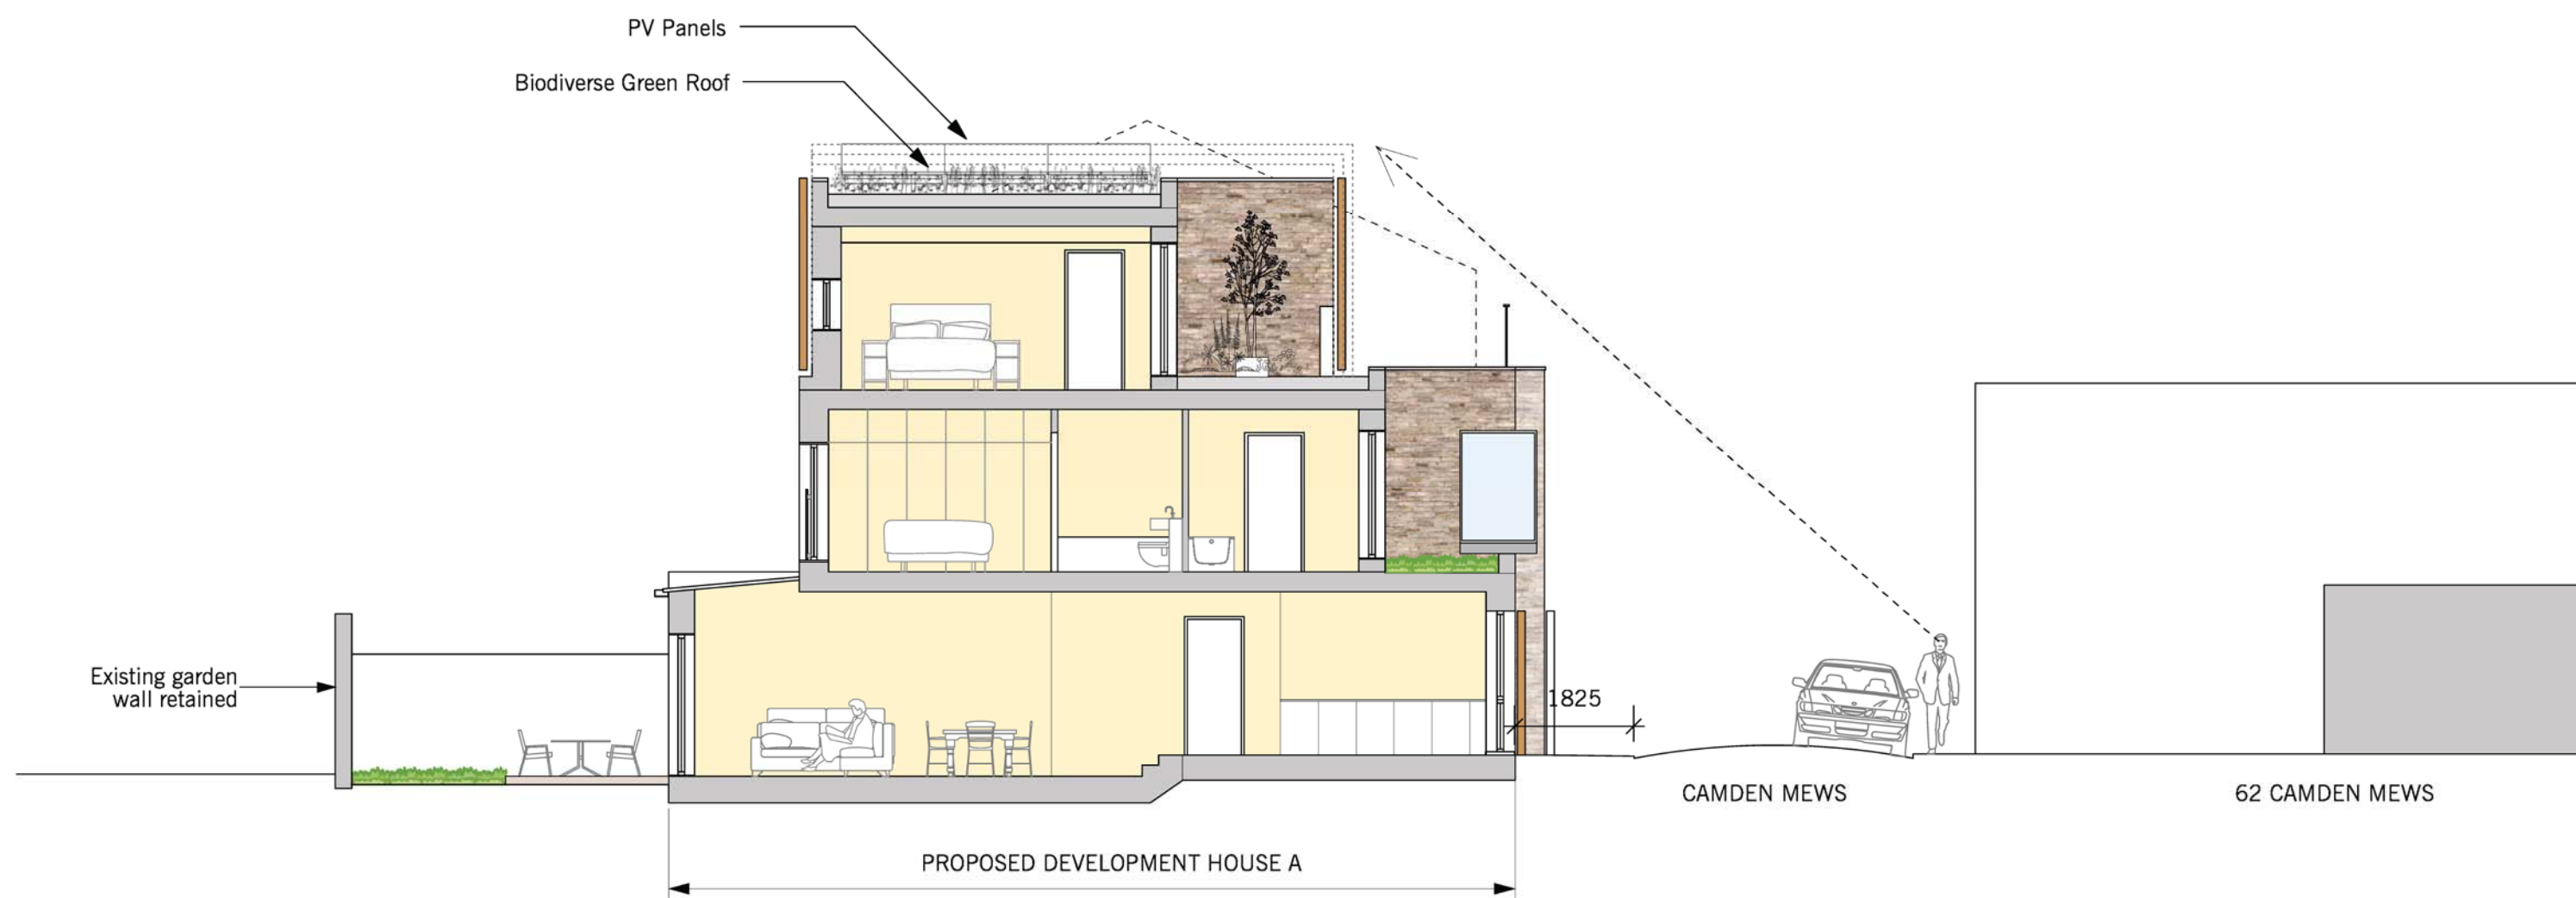
Revision A:
Building line moved back from Camden Mews by 100mm.
Laser cut steel panel balustrade introduced to Houses A&C
and set back from the boundary to House A. Timber trellis to
rear gardens omitted.

Revision B:
Window height to Camden Mews revised to accord with
changes to front elevation.

Revision C:
Building line of House A moved back from Camden Mews by
200mm. House A lowered by 430mm. Laser cut steel panel
balustrade changed to glass balustrade.

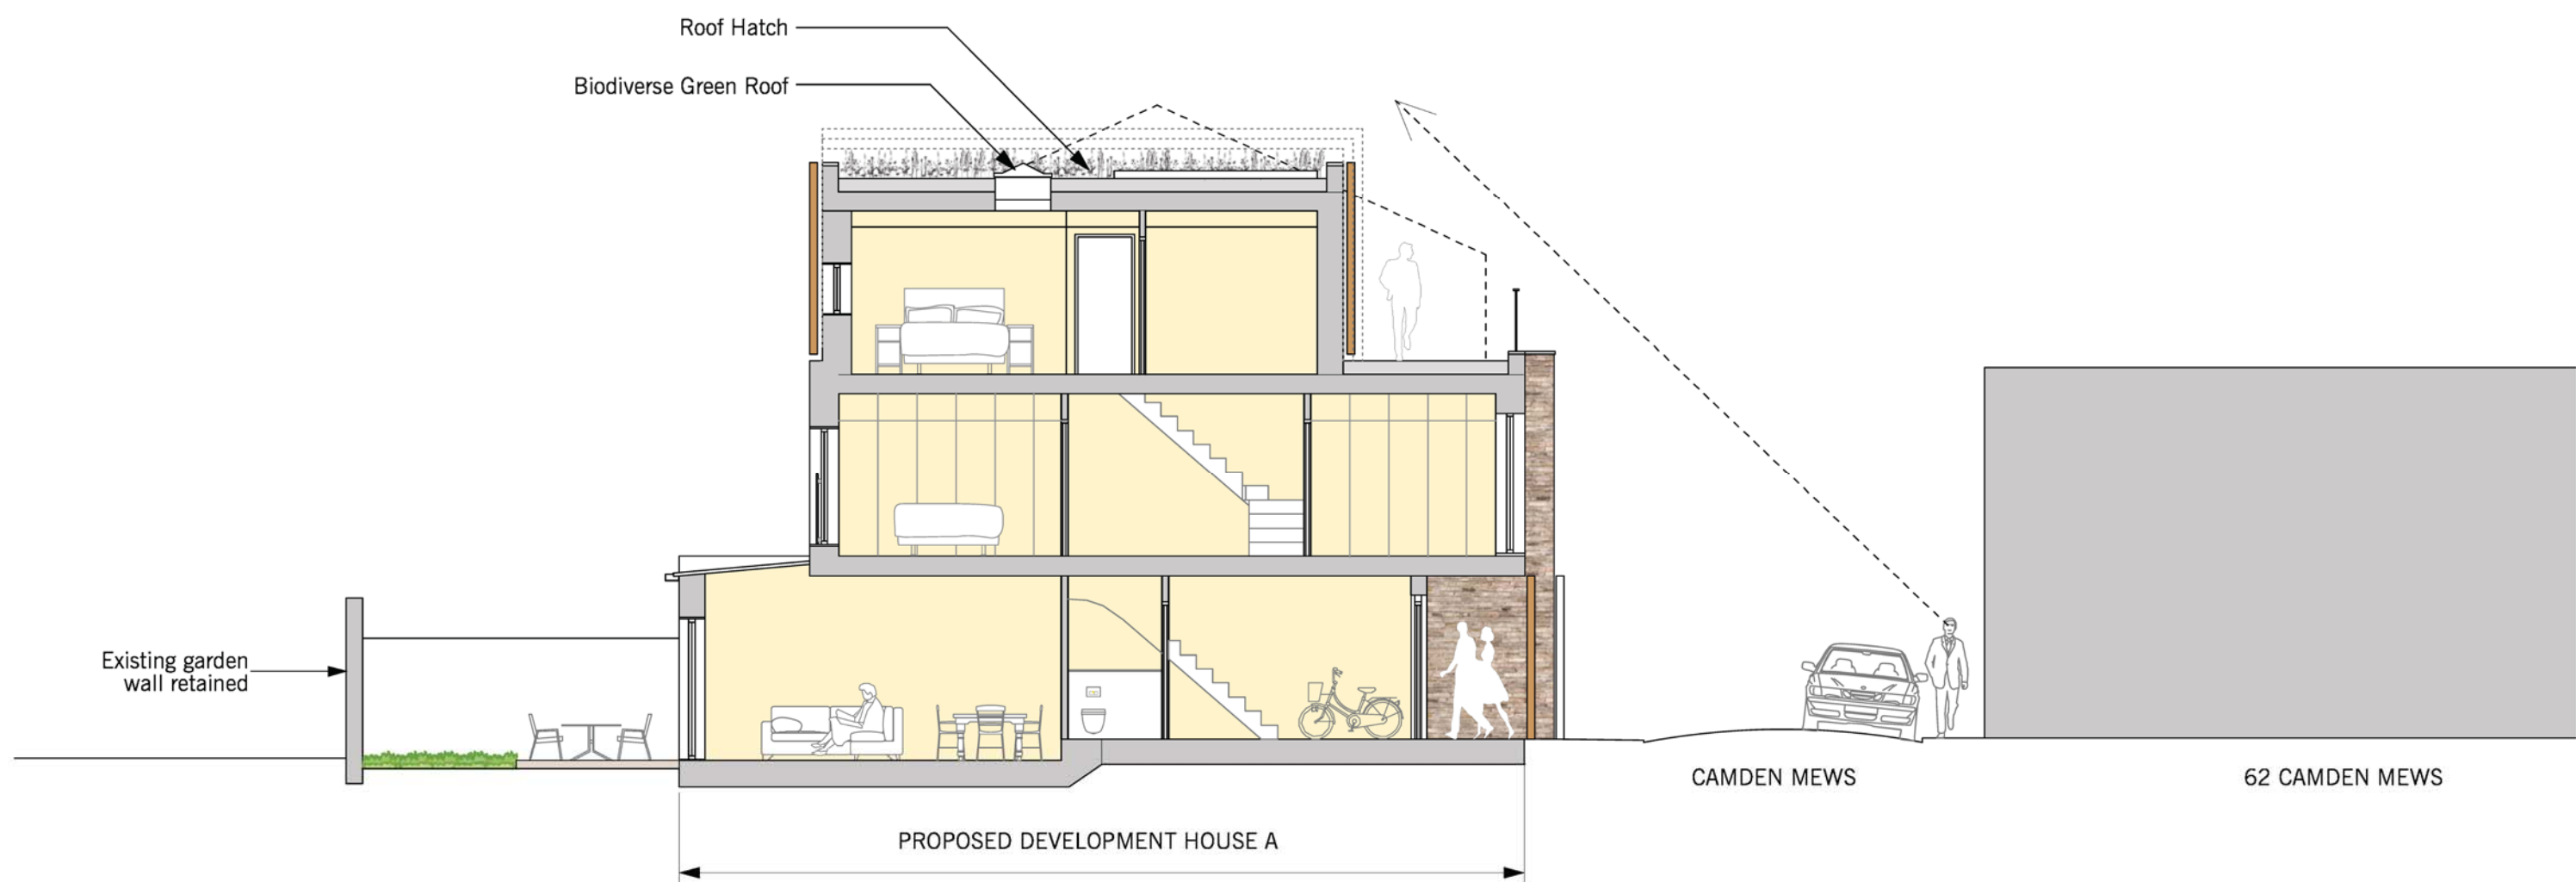
Revision A:
Building line moved back from Camden Mews by 100mm.
Laser cut steel panel balustrade introduced to Houses A&C
and set back from the boundary to House A. Timber trellis to
rear gardens omitted.

Revision B:
Window height to Camden Mews revised to accord with
changes to front elevation.

Revision C:
Building line of House A moved back from Camden Mews by
200mm. House A lowered by 430mm. Laser cut steel panel
balustrade changed to glass balustrade.

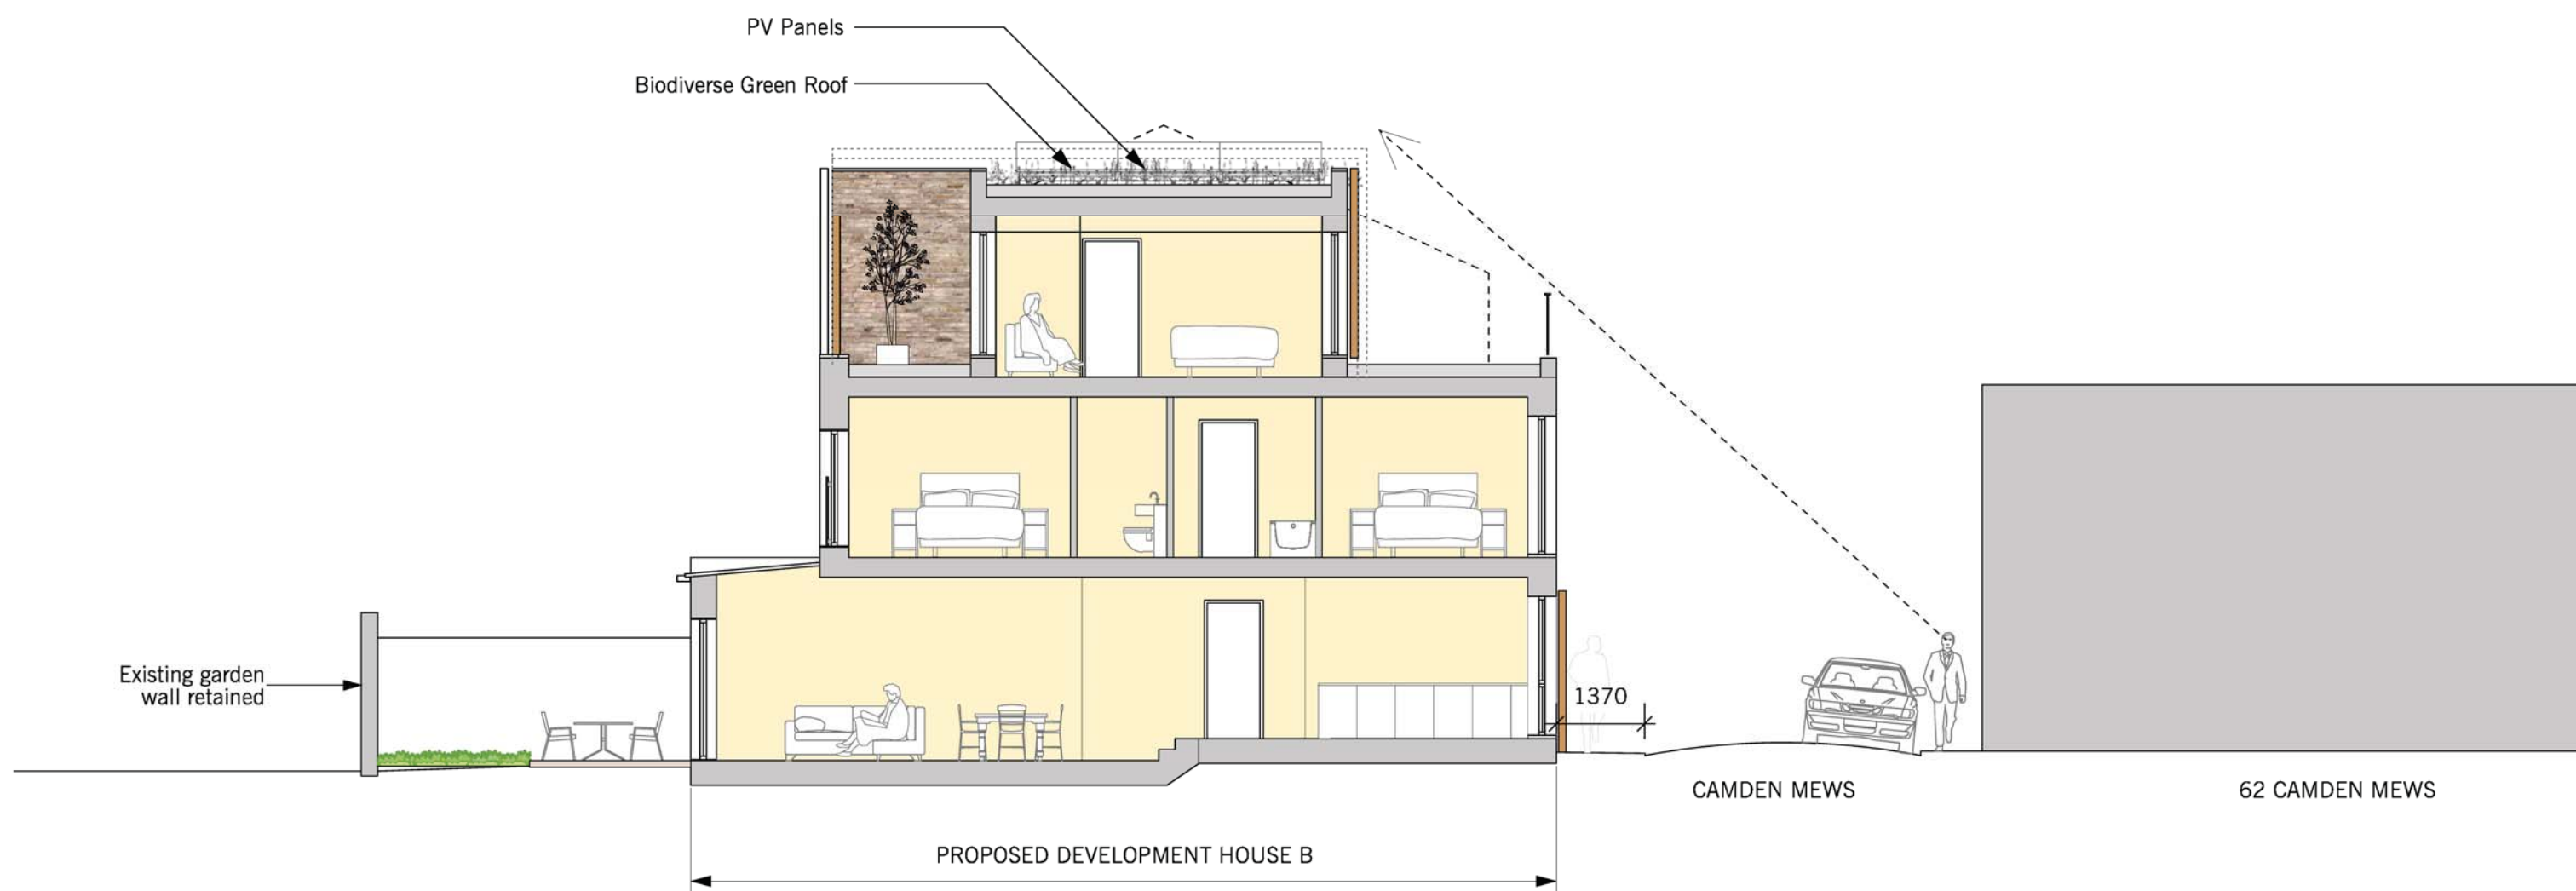
Revision A:
Window height to Camden Mews revised to accord with changes to front elevation. Sliding slatted hardwood screens omitted.

Revision B:
House B lowered by 215mm

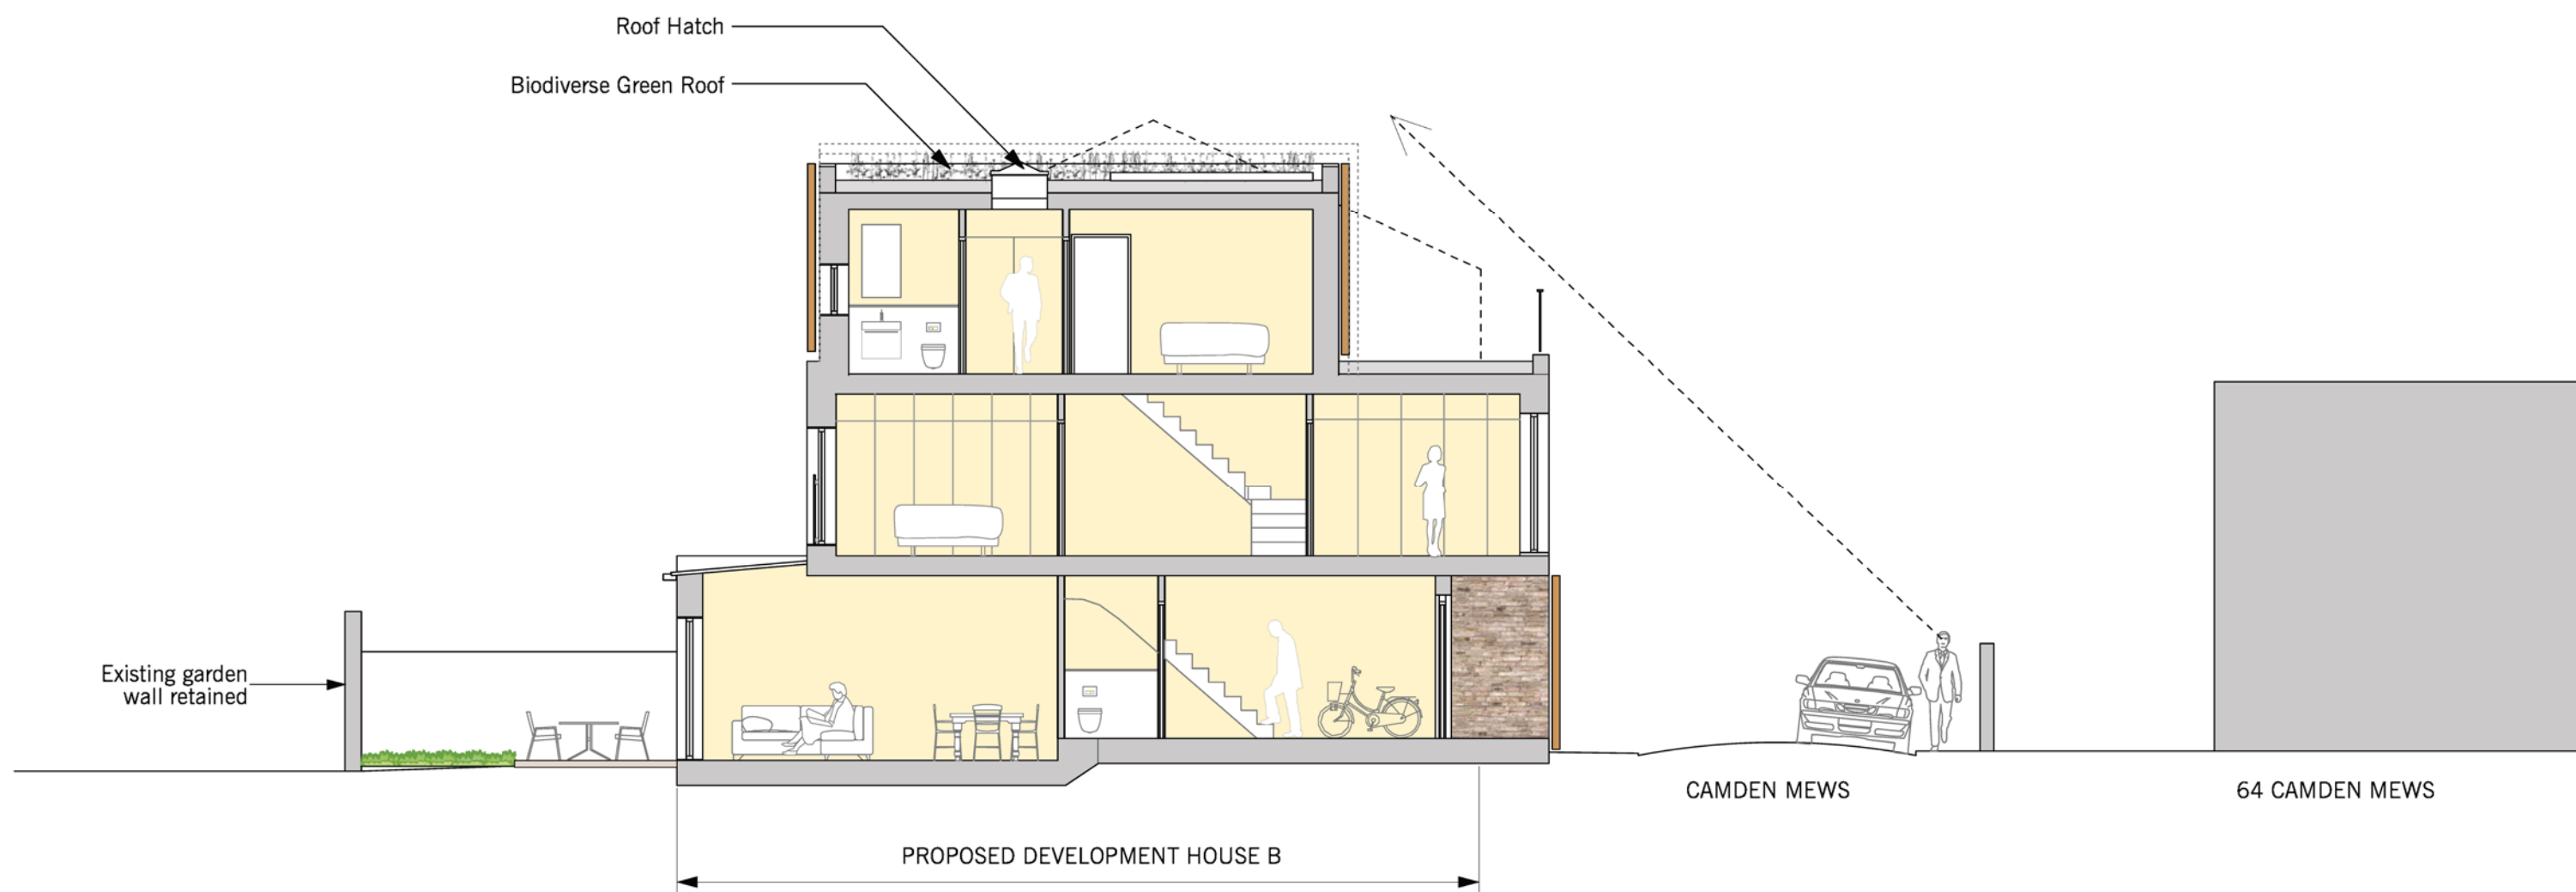
Revision A:
Window height to Camden Mews revised to accord with changes to front elevation. Sliding slatted hardwood screens omitted.

Revision B:
House B lowered by 215mm
